January 8, 2019

Subject: Response to Comments for 32nd and C Street (City of San Diego Project No. 595288)

ACOUSTICAL ANALYSIS REPORT

32nd and C Street
San Diego, California 92102

Site Plan Showing Outdoor Use Area
Receiver and Barrier Locations
Job # B80709N1

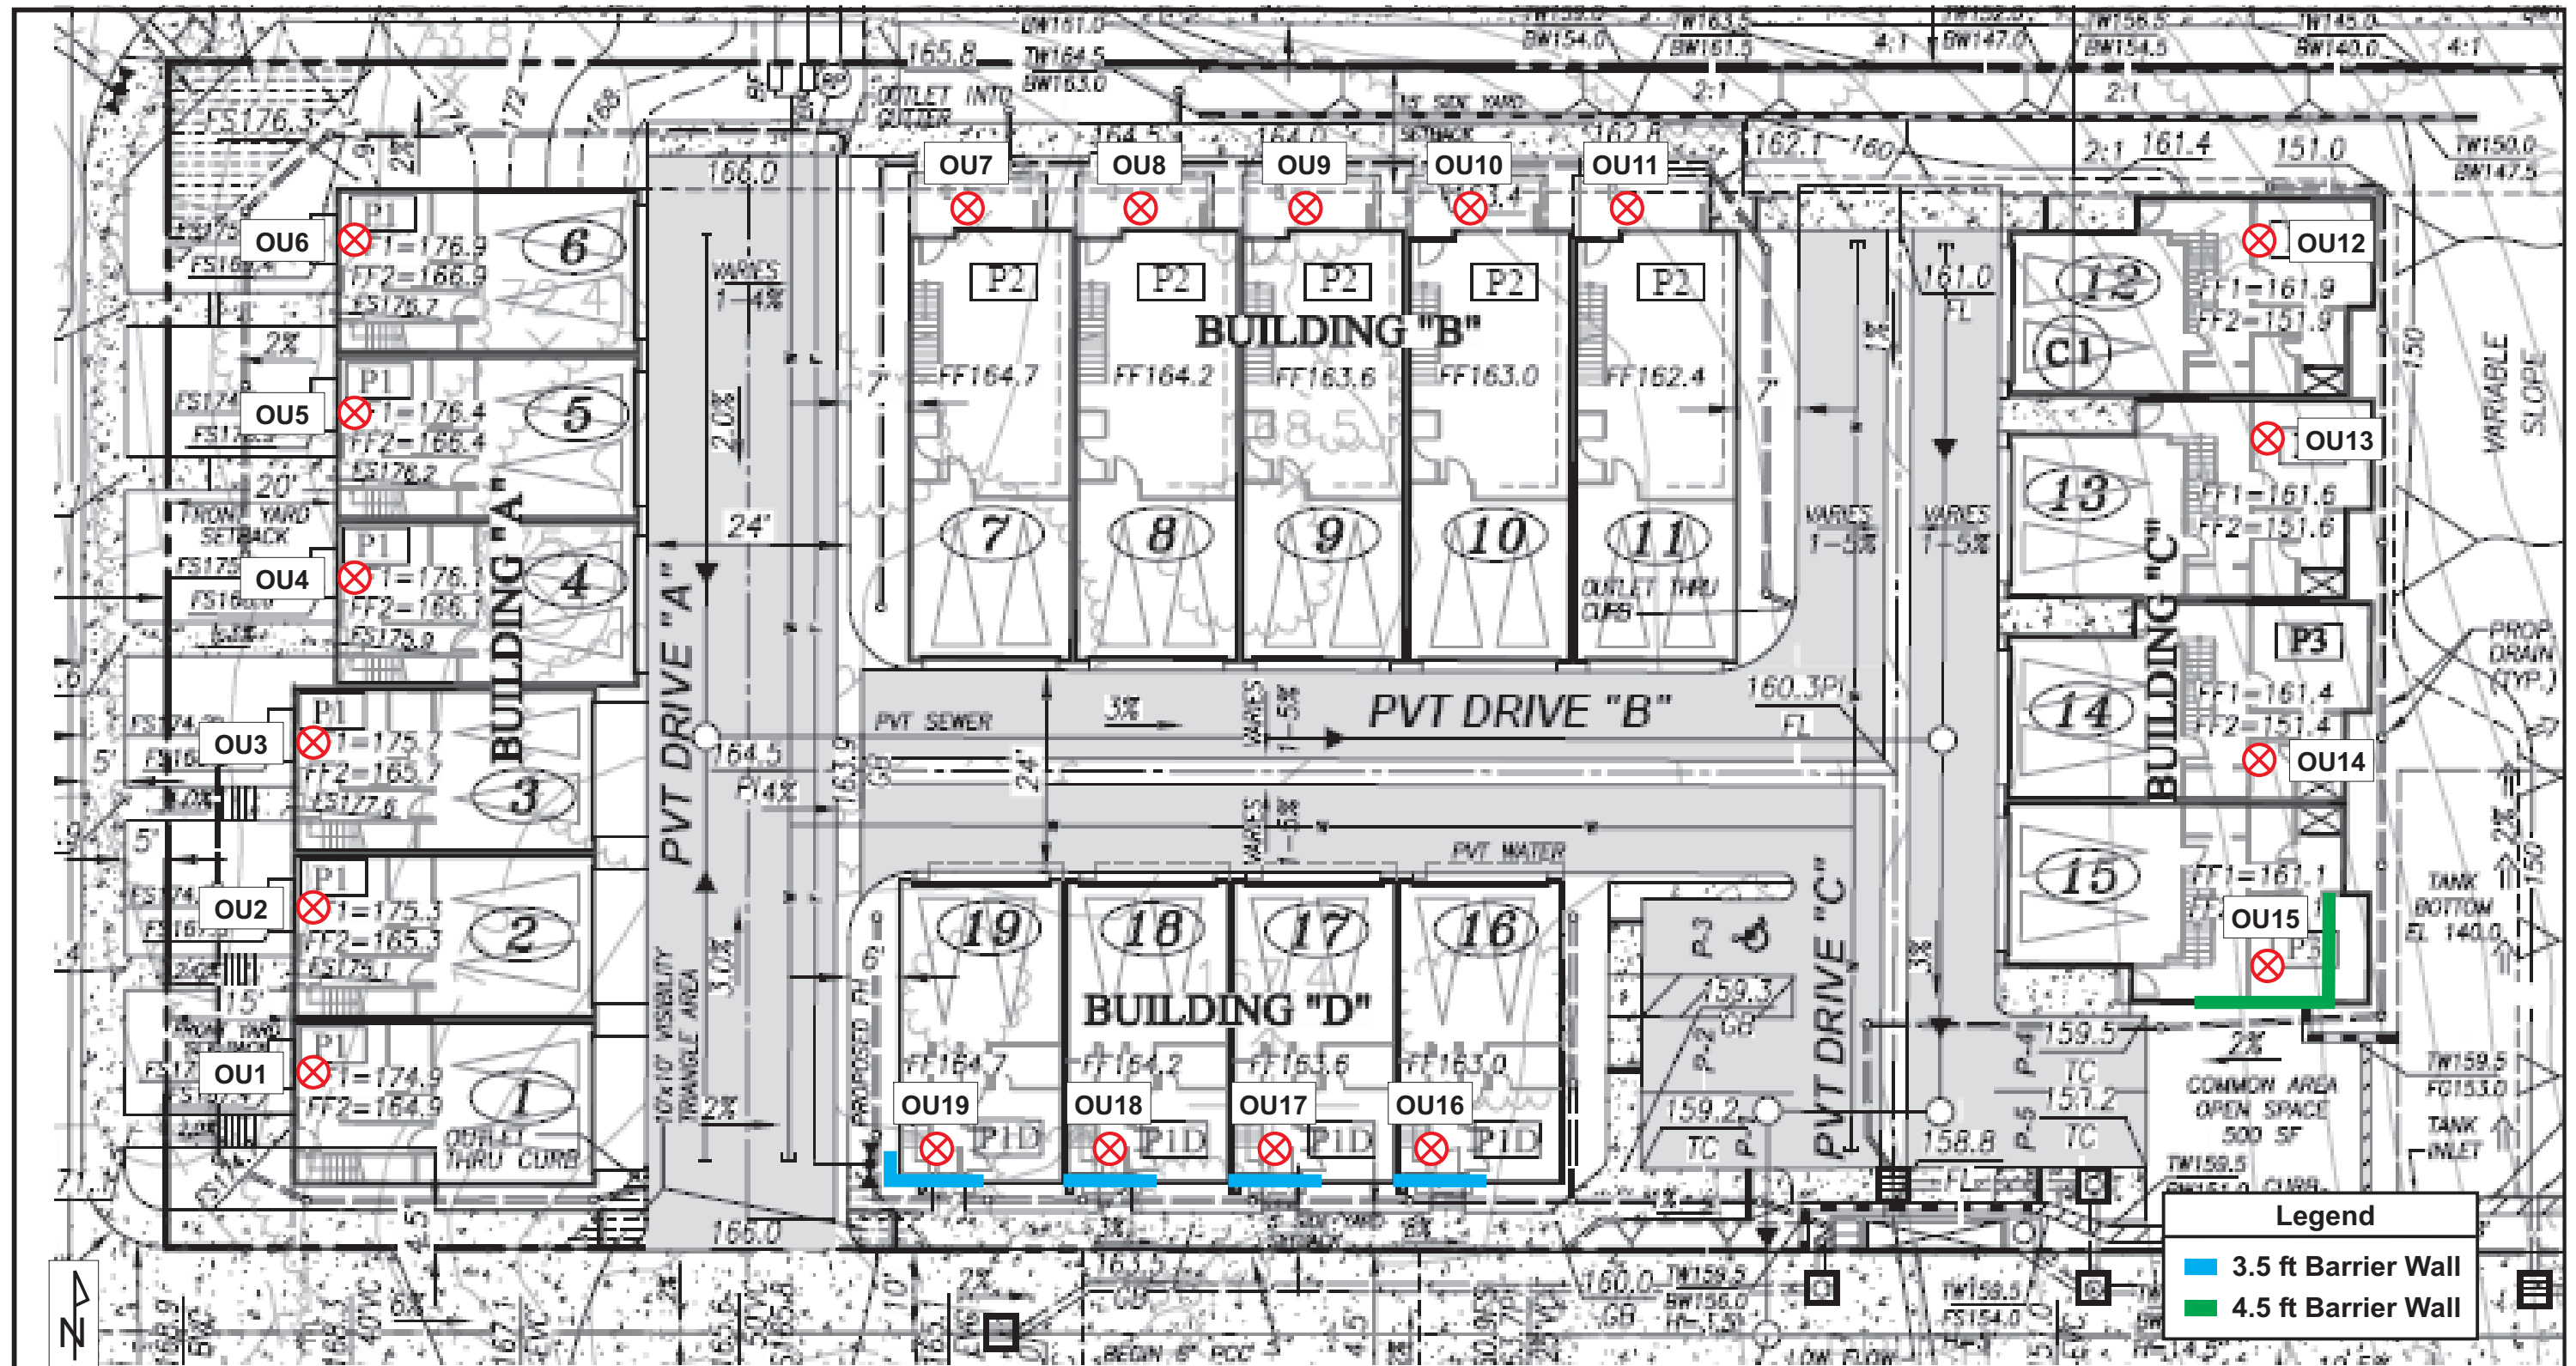
103. *Page 10: Based on the analysis it looks like sound attenuation barriers are required on the balconies of Units 15 through 19. Clearly state the location of these barriers in the analysis and what these sound barriers would be constructed of (e.g. stucco, etc.) Also provide a note on the Site and Elevations Plans clearly stating what the sound attenuation barriers would be constructed of and their location.*

RESPONSE: Page 10 of the report has been revised to state the location of sound attenuation barriers in the analysis. Page 10 of the report also details the materials that should be used in the construction of sound attenuation barriers. Regarding the note on the Site and Elevations Plans, this item has been brought to the attention of the architect.
